Technical Bulletin

Number 187

August 20, 2007

Mid Range Tumbler Tie Rod Nuts “Loctite®”

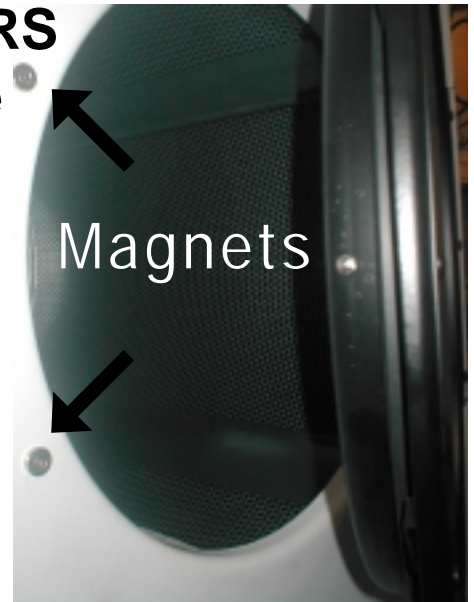
As a precautionary measure to avoid the tumbler tie rod nuts from loosening, Loctite® #262 thread lock is now used to secure the nuts in place. This change was implemented into production on July 12, 2007 and affects models AD-115, AD-120, AD-170, and related models.
